APPENDIX D ARDG RESPONSE TO DPE WATER

Hills of Gold Wind Farm (SSD-9679) Amended Report – ARDG Response to DPE Water Request for Additional Information

Below is a response to the request for further information from DPE Water in relation to potential for the Verden Road Quarry Project to intersect a groundwater aquifer.

Figure 4 – Western and Eastern Operations Extraction Areas local topography overview and cross sections orientation

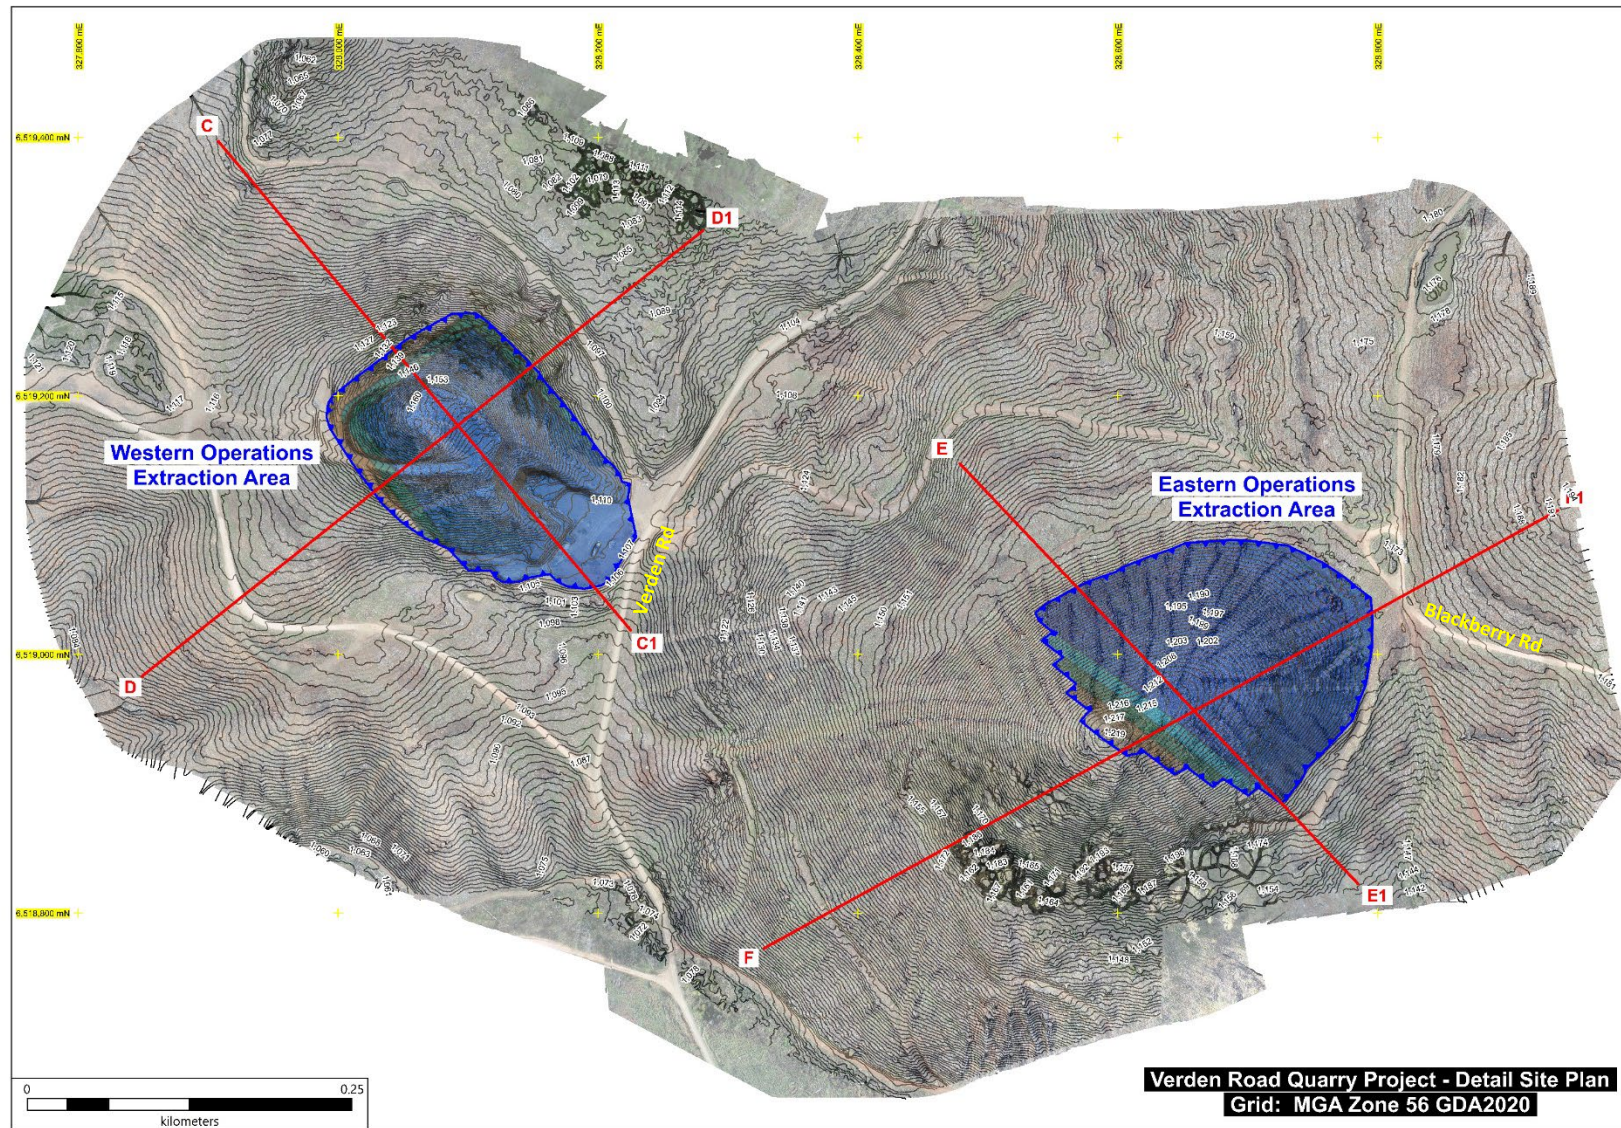
In the case of the proposed Western Operations Area, the highest elevation of the point where the hill ‘intersects the broader surrounding landscape’ is located at the saddle on Verden Road, at the front entrance (east) of the existing quarry (refer **Figure 4** and **Figure 9**). The elevation of the saddle is between 1106 and

In the case of the proposed Eastern Operations Area, the highest elevation of the point where that hill 'intersects the surrounding landscape' is located at the saddle on Blackberry Road (north-eastern side of hill). The elevation of the saddle is between 1172 and 1173 mAHD, and logically if a groundwater aquifer exists, it must occur below that depth. The proposed maximum depth of extraction in the Eastern Operations Area is 1174m AHD (refer **Figure 4** and **Figure 10**).

In the case of the proposed Western Operations Area, it is proposed to extract to a level no deeper than the existing level (1108 mAHD) of the FCNSW processing area (refer **Figure 4** and **Figure 9**). Extraction depth in the Eastern Operations Area is proposed to a similar relative level (refer **Figure 4** and **Figure 10**).

Based on the logic and observations outlined in **Section 2**, the shallow extent of proposed quarry extraction within the Project Area is not expected to intersect any groundwater aquifer, which if present, must be located at a depth below the level of proposed extraction in the proposed Western and Eastern Operations Areas (refer **Figure 4** and **Figures 9 – 10**).

Figure 9 – Western Operations Extraction Area cross-sectional view (refer Figure 4 for cross-section reference). Proposed extraction depth shown is above the basal level of the hill / basalt. Note the existing extraction operation profile shown in Section C – C1

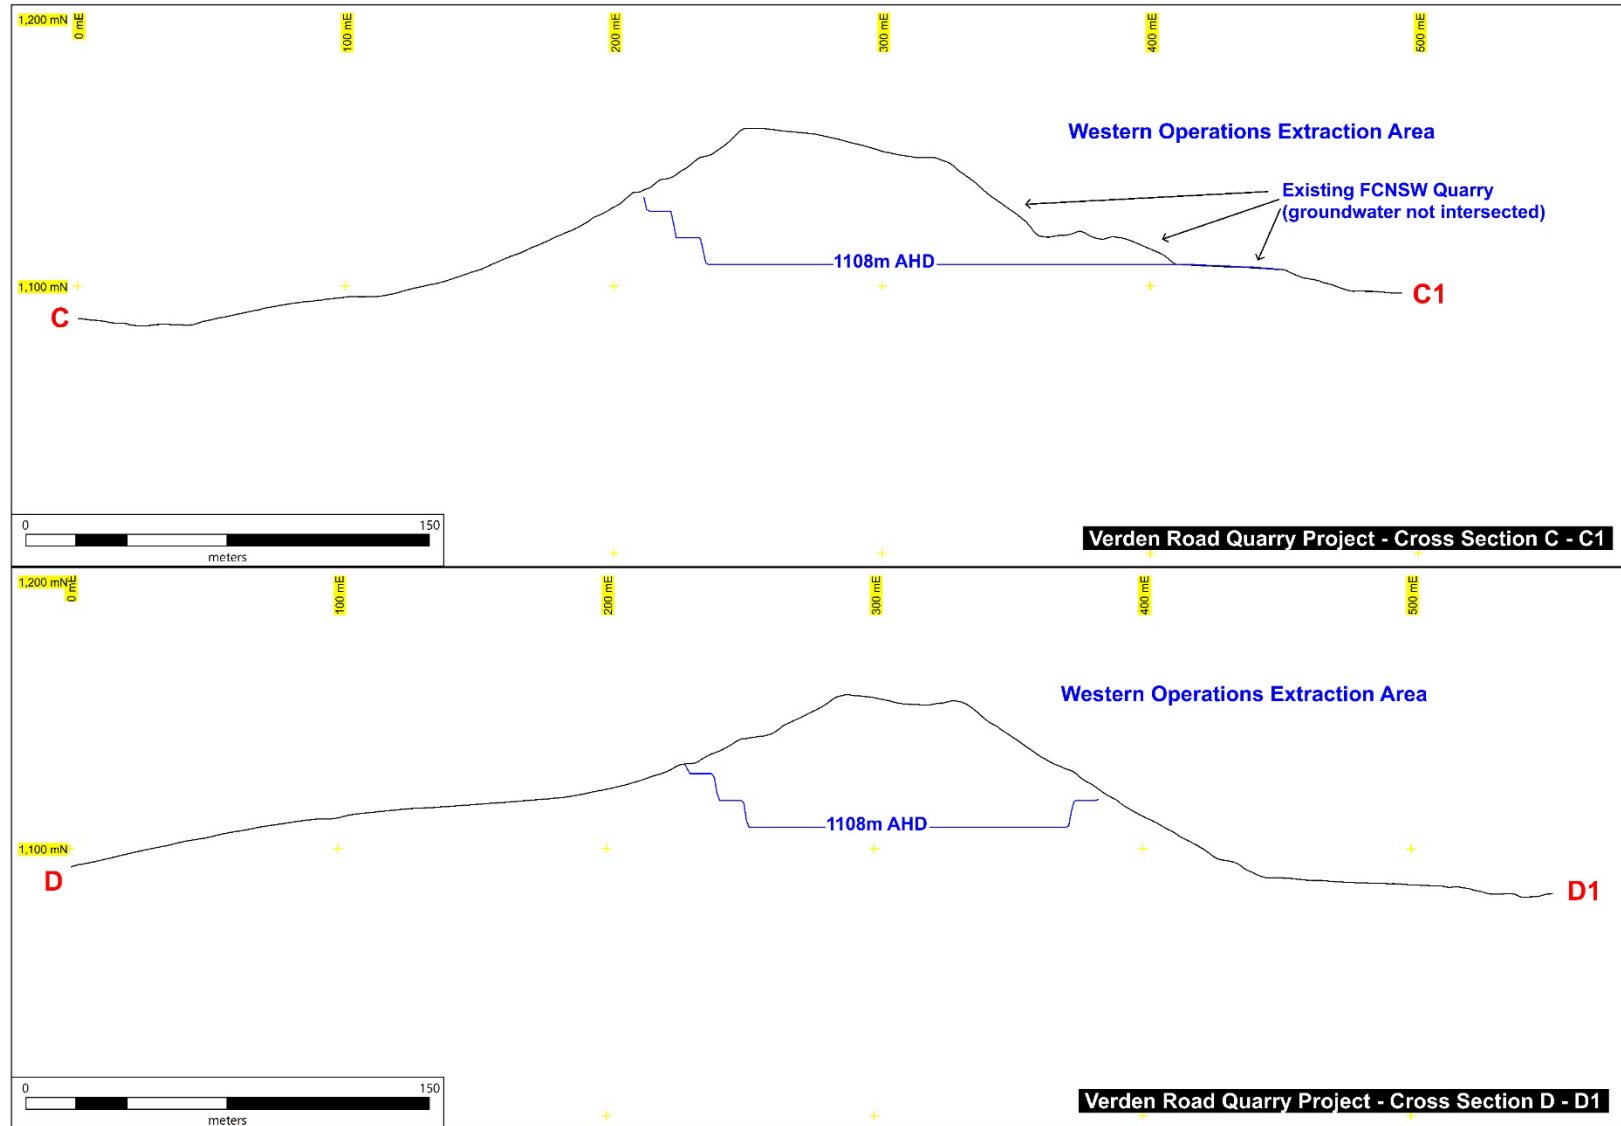
1107 mAHD, and logically if a groundwater aquifer exists, it must occur below that depth. The proposed maximum depth of extraction in the Western Operations Area is 1108 mAHD.

- FCNSW has operated the existing Verden Road Quarry since early 2020 and has extracted the eastern flank of the hill from the peak down to the level of the current processing area (*i.e.* maximum extraction level proposed by ARDG of 1108 mAHD) (refer **Figure 4** and **Figure 9**). FCNSW has advised ARDG that quarrying to date has not encountered any groundwater seepage from the faces of the extraction area or intersected any groundwater in the existing quarry operation. The absence of any groundwater is particularly relevant in the context of an extremely wetter than usual 'La Nina' climatic environment over the last three years.
